October 7, 2016
Project No. 8128.02.02

Re: Siltronic Comments on Proposed Revisions to the NW Natural Gasco Groundwater Monitoring Program

Siltronic Corporation
Portland, Oregon

Figure Monitoring Well Locations

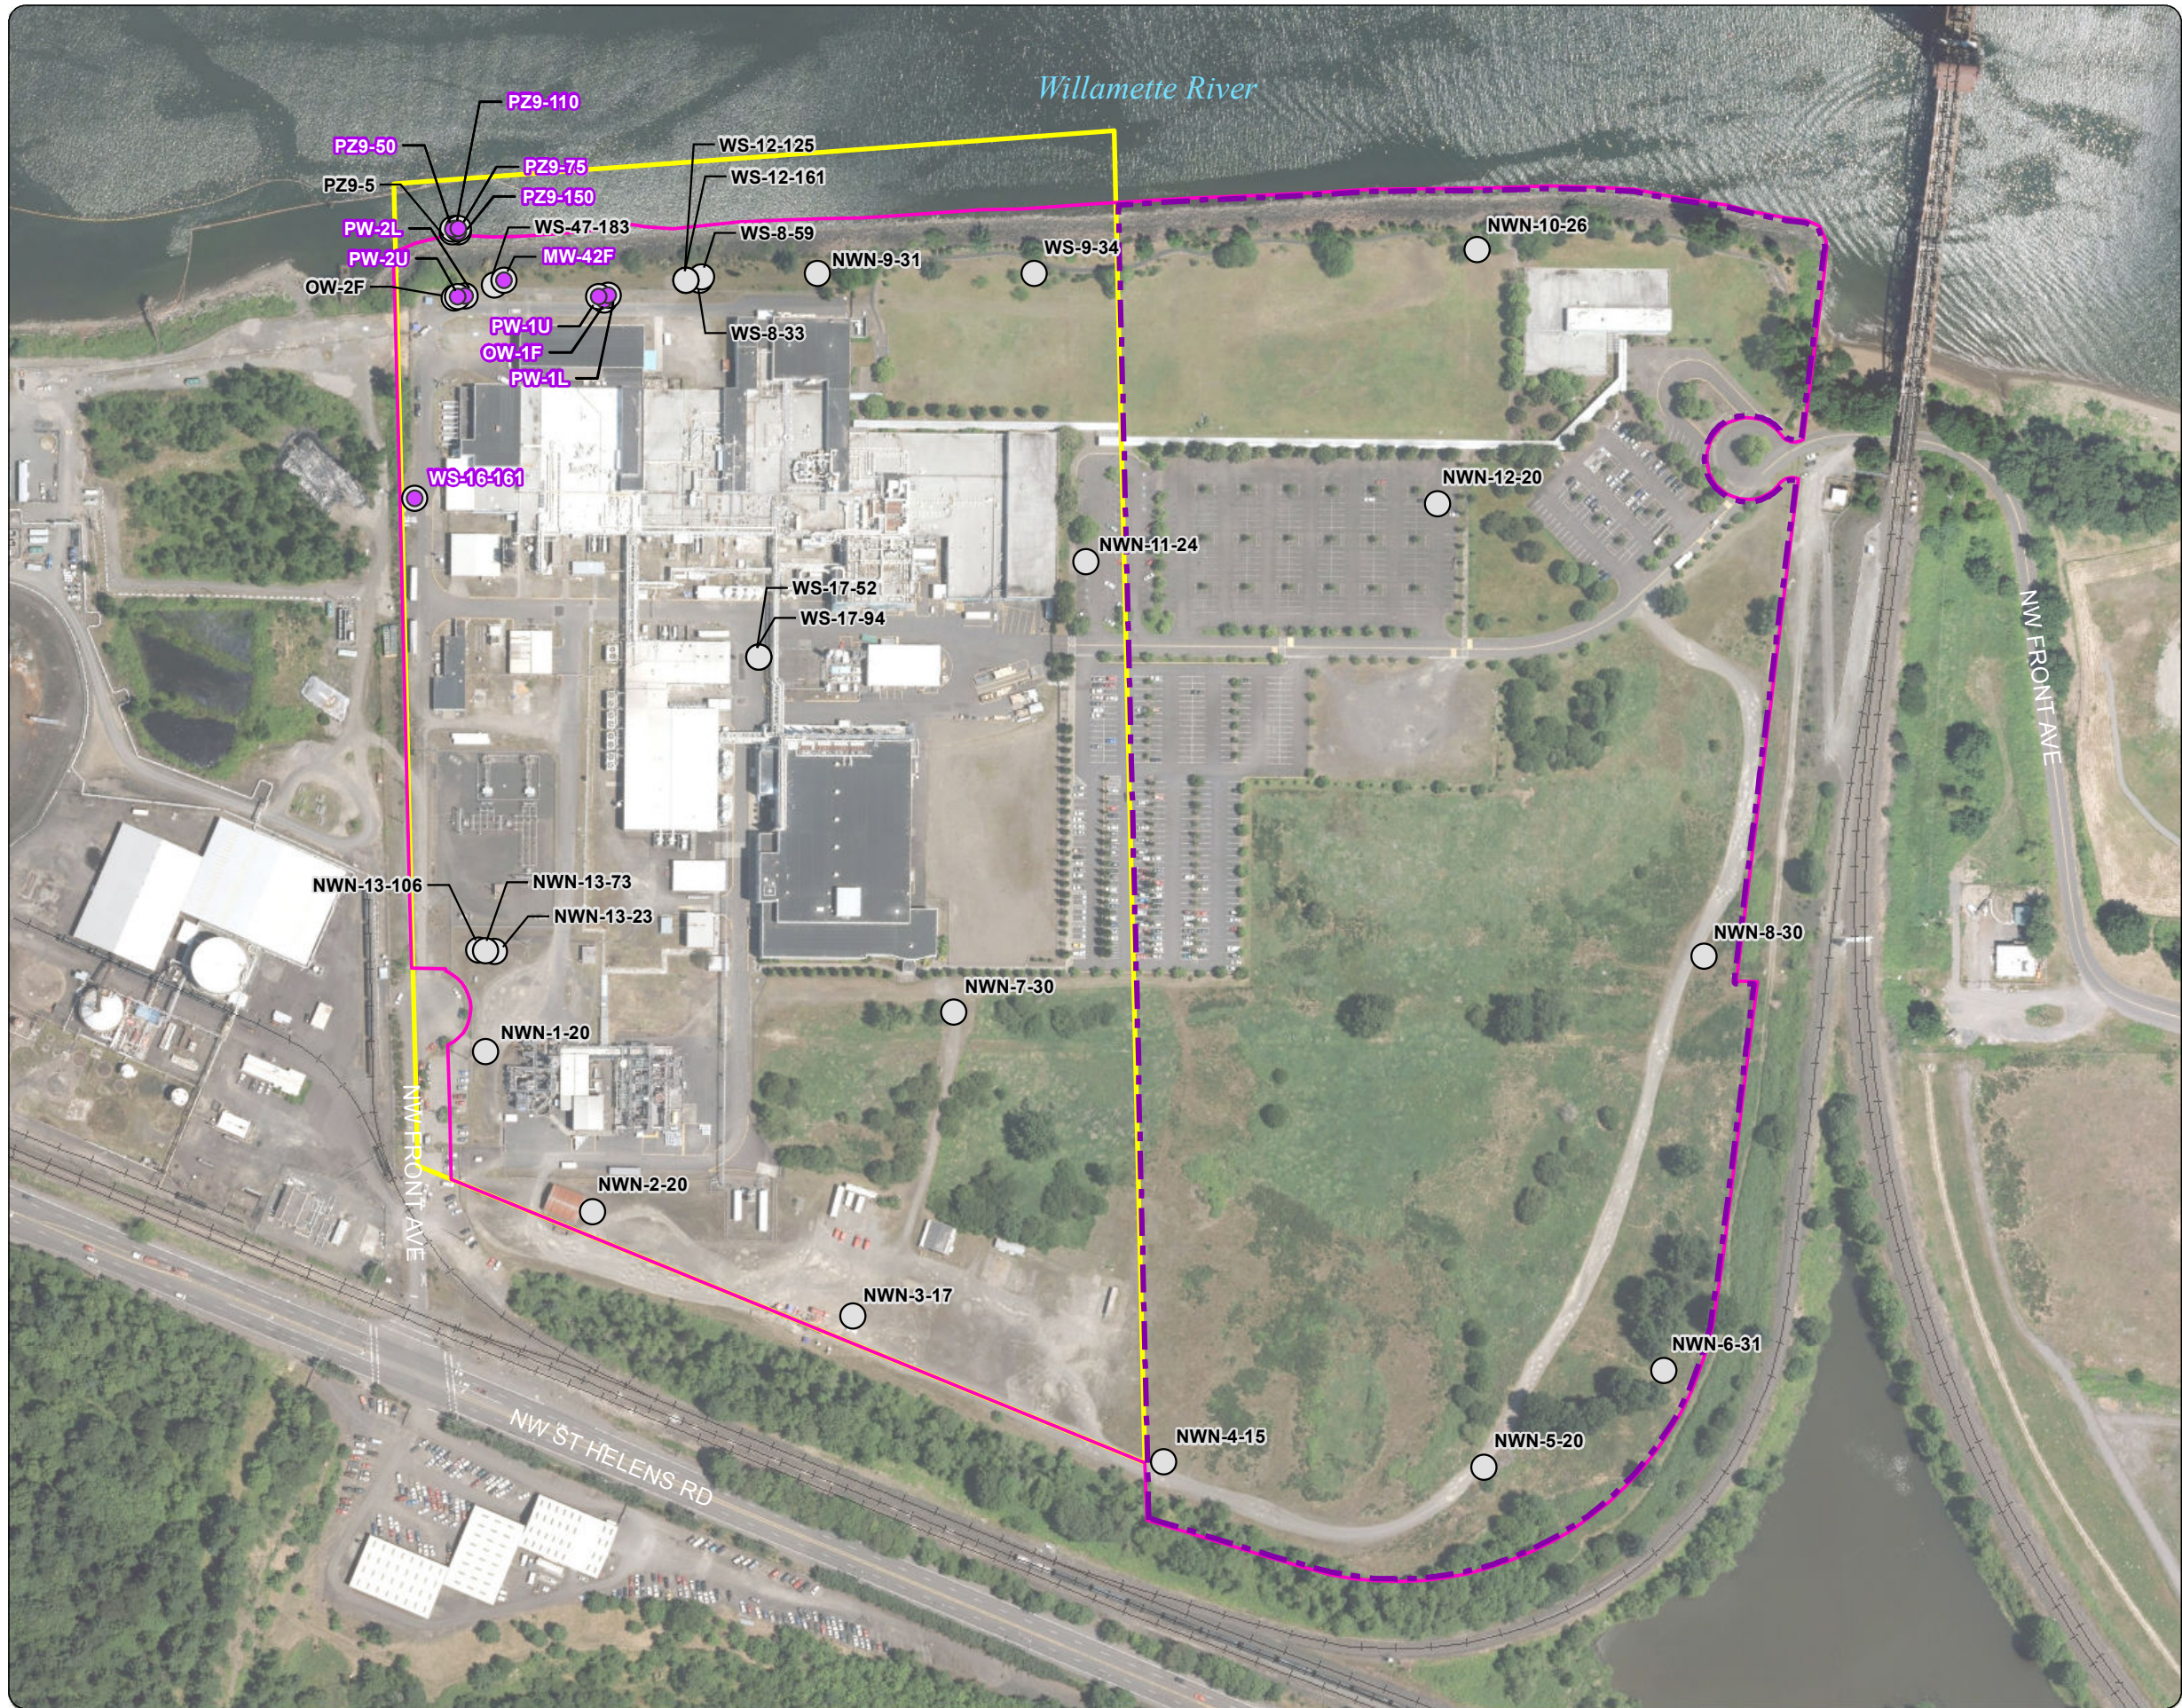
The monitoring reduction memorandum proposes a reduction in the quantity of well locations as well as the frequency of groundwater sample collection prescribed in the current monitoring program. The attached figure shows the wells encompassed by the DEQ-approved monitoring program on Siltronic property and which of these wells would no longer be monitored. The existing DEQ-approved monitoring program includes 38 wells on Siltronic property, whereas the proposed monitoring program includes only 11 well locations. The rationale provided in the NWN monitoring reduction memorandum is that "the nature and extent of groundwater contamination has been fully characterized throughout OU1."² We believe this assertion is incorrect because of significant data gaps that are due to the limited list of constituents of interest (COIs) that NWN has relied on to date, as described in Siltronic comments on the remedial investigation and risk assessment (RA) addendum annotated outline.³
